Design & Access Statement

Rev A
20/08/2015

107 Gray's Inn Road
Charles Darwin House Ltd.

The application is submitted on behalf of Charles Darwin House Ltd. to obtain planning permission for the additions made to the office building, namely the inclusion of louvred enclosures to the side of the rear facade at ground floor level and the addition of a Plant Room on the fourth floor.

Proposed Ground Floor Plan - Drawing 3257-2150R

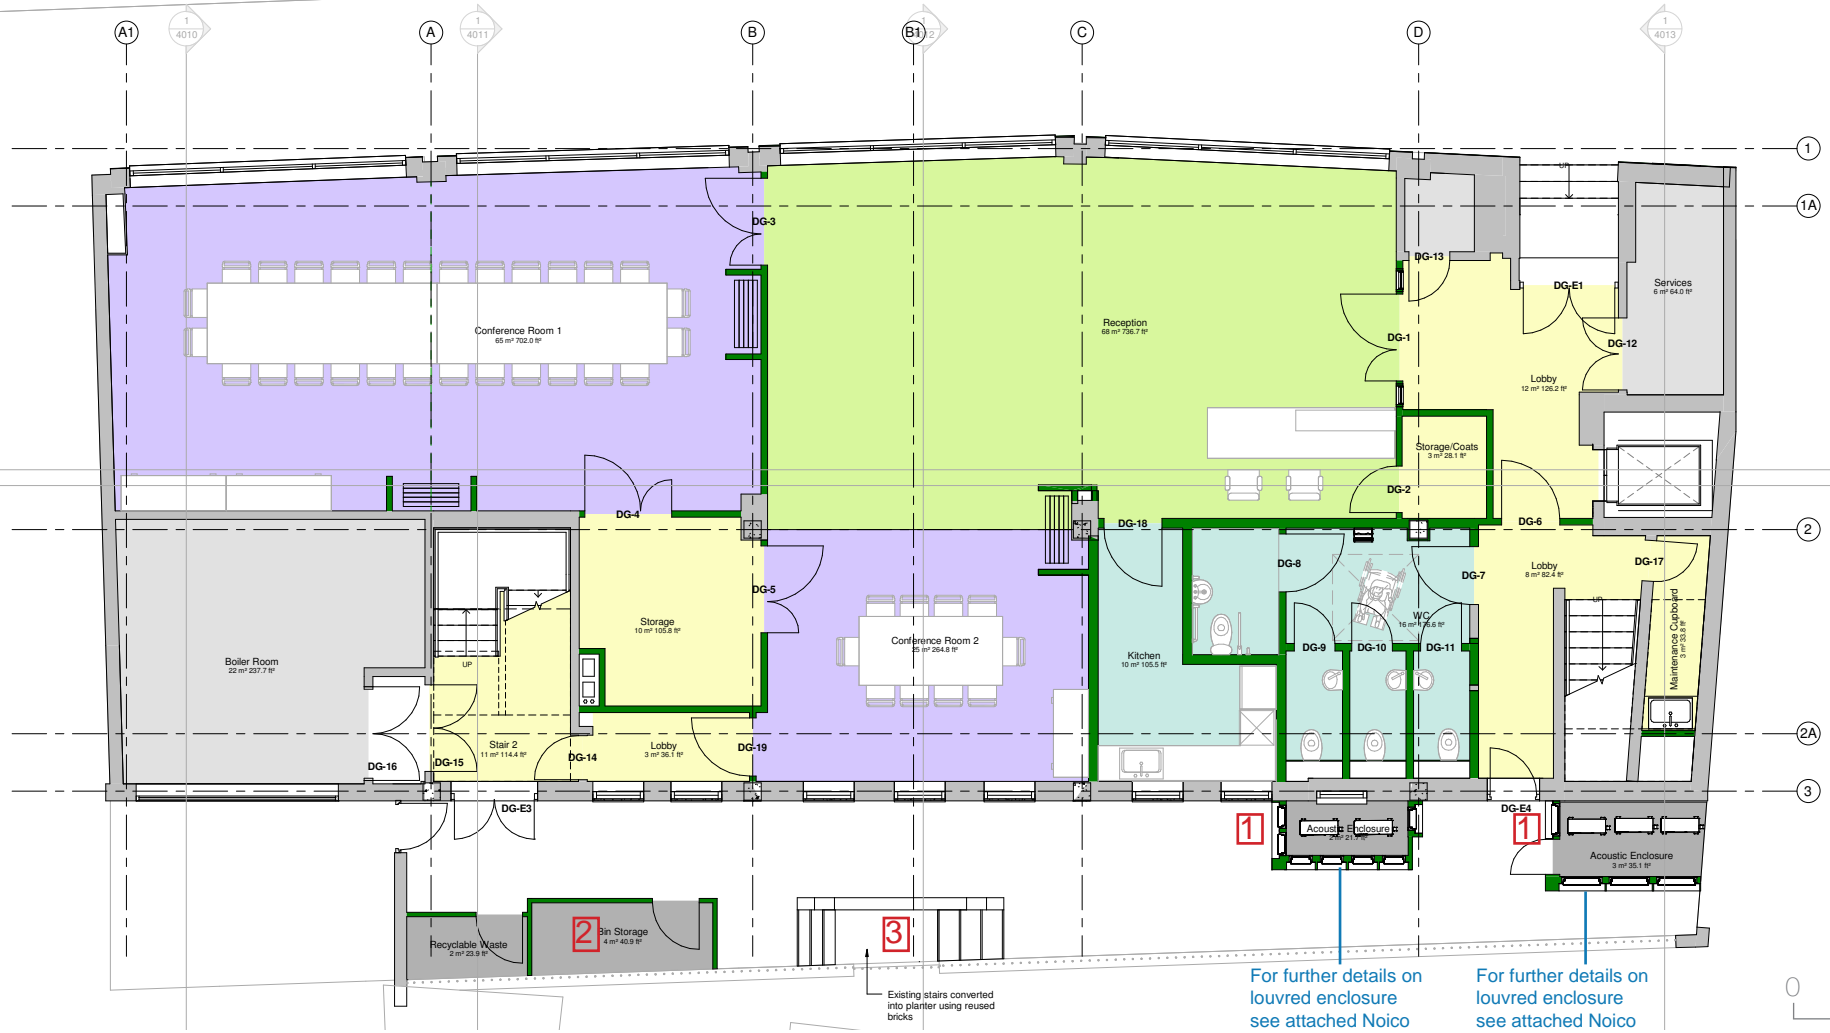
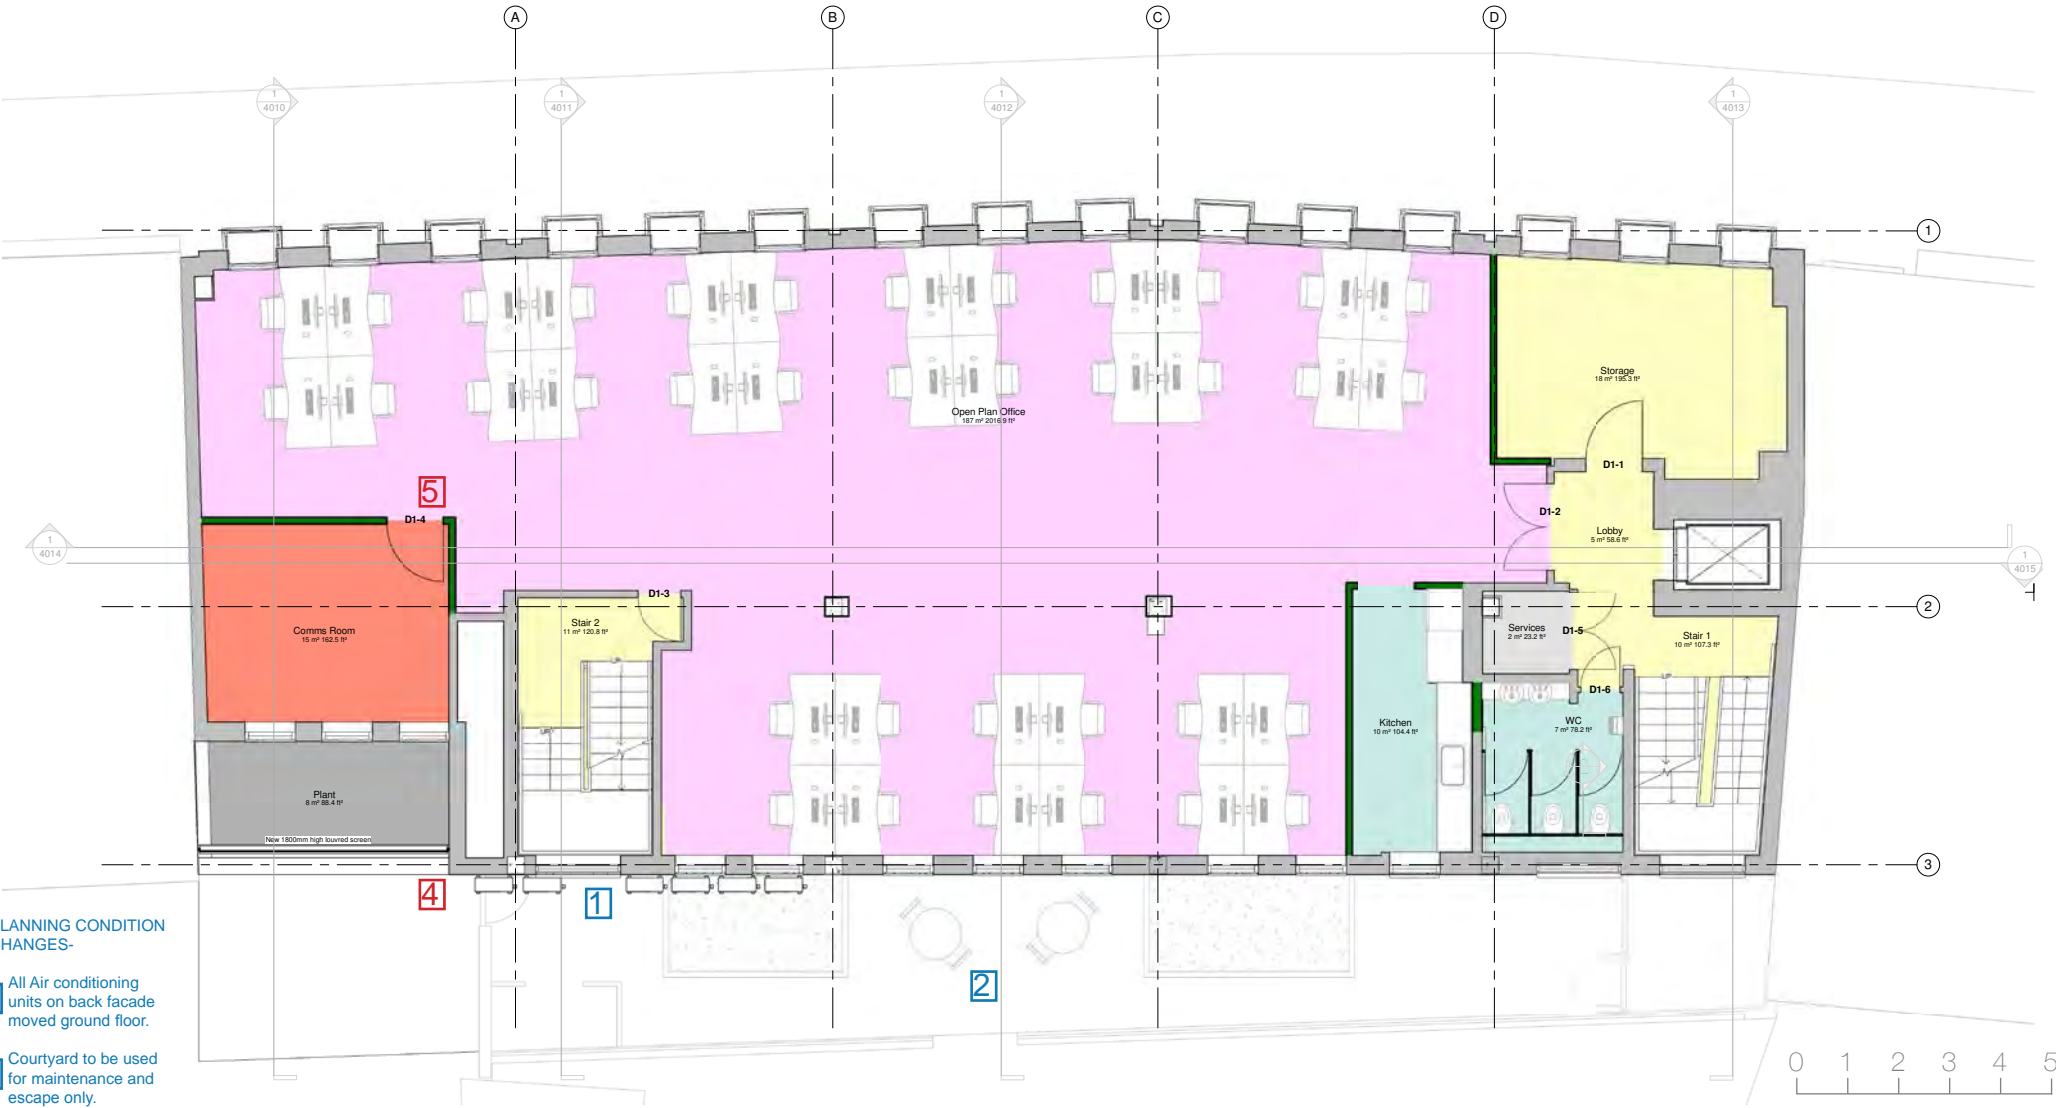
1
Acoustic Enclosures added to prevent noise disruption to local surroundings. (See attached Hawkins Acoustic Report)
Air Conditioning units position moved to be in Acoustic Enclosures

2
Bin Storage moved as a result of acoustic enclosures

3
Proposed planters removed, existing stairs converted into new planter

Proposed First Floor Plan - Drawing 3257-2151L

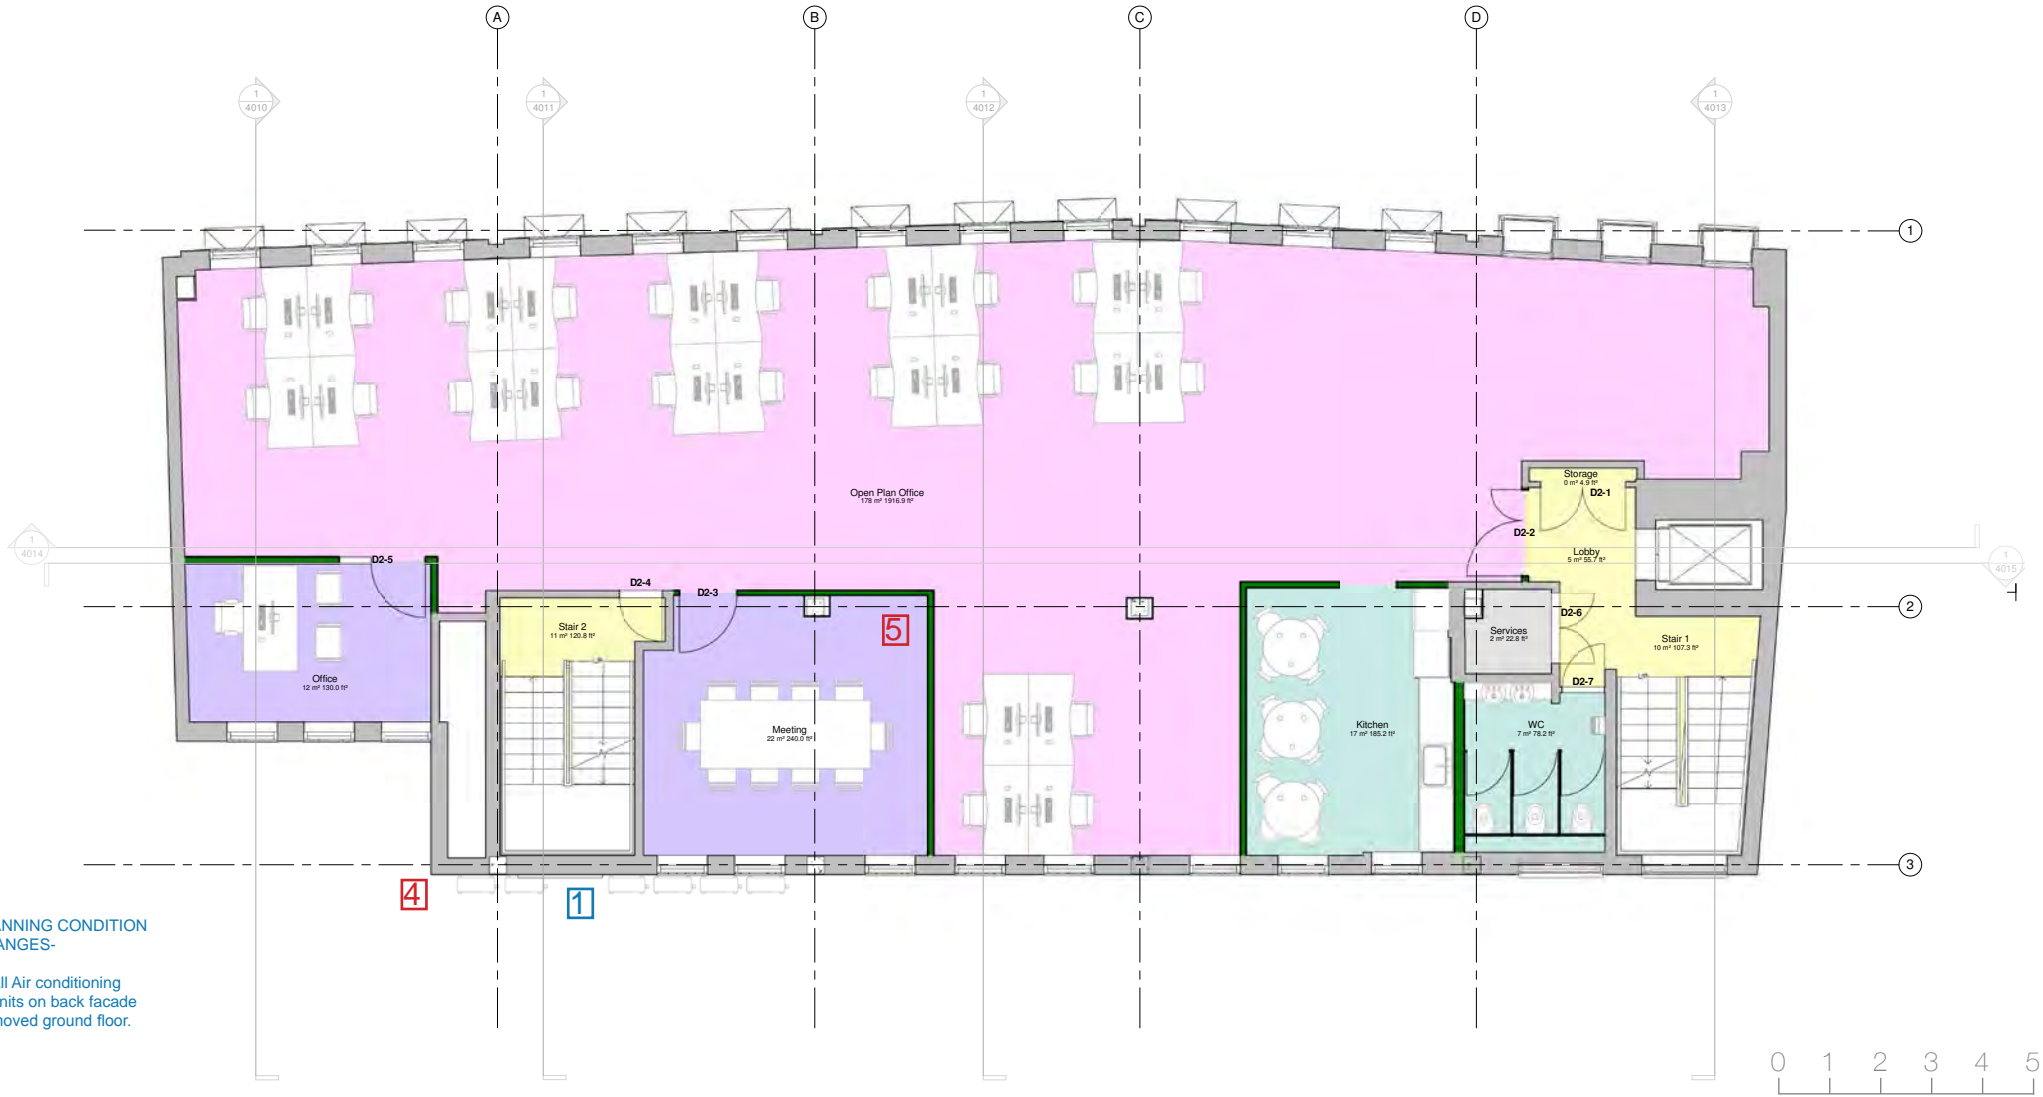
Position of wall is as existing, no change has occurred. Existing fabric shown on the consented drawings was subject to survey.

Office layout developed, enlarged Comms Room.

Proposed Second Floor Plan - Drawing 3257-2152S

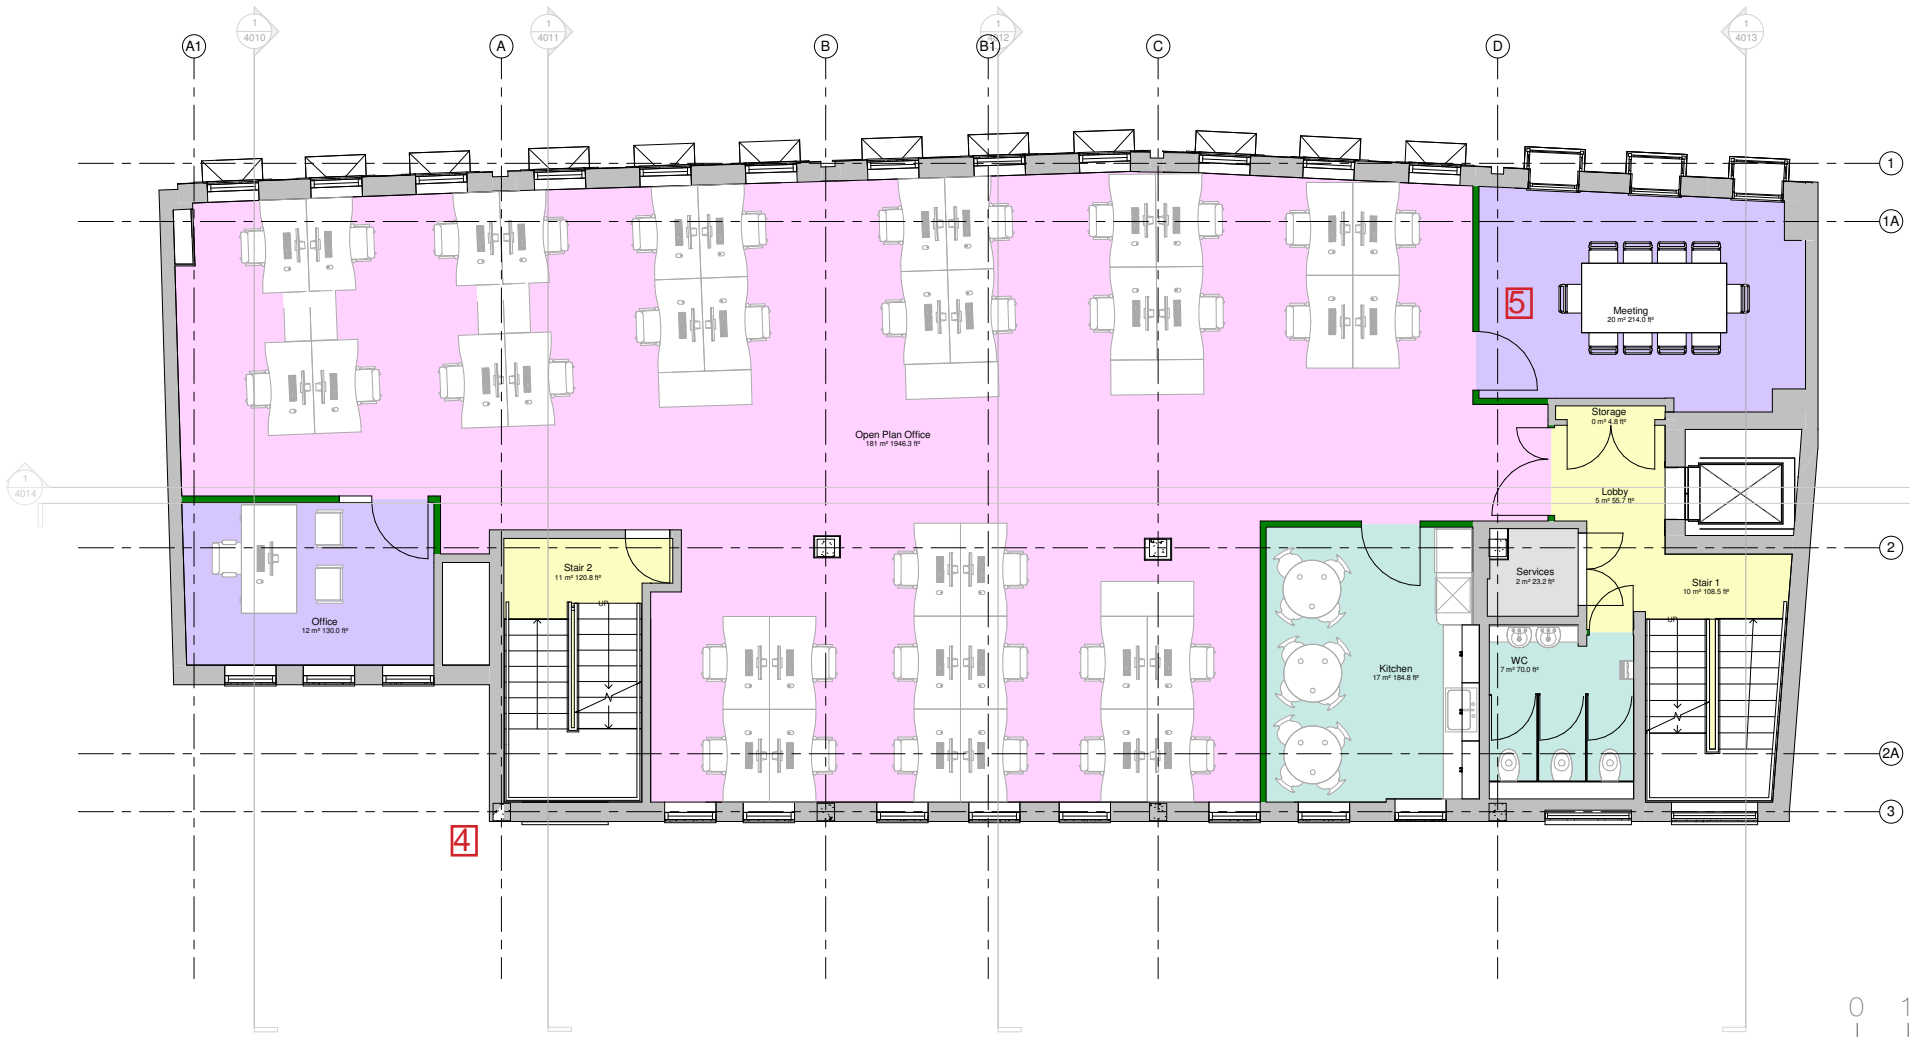
Position of wall is as existing, no change has occurred. Existing fabric shown on the consented drawings was subject to survey.

Office layout developed, minor changes.
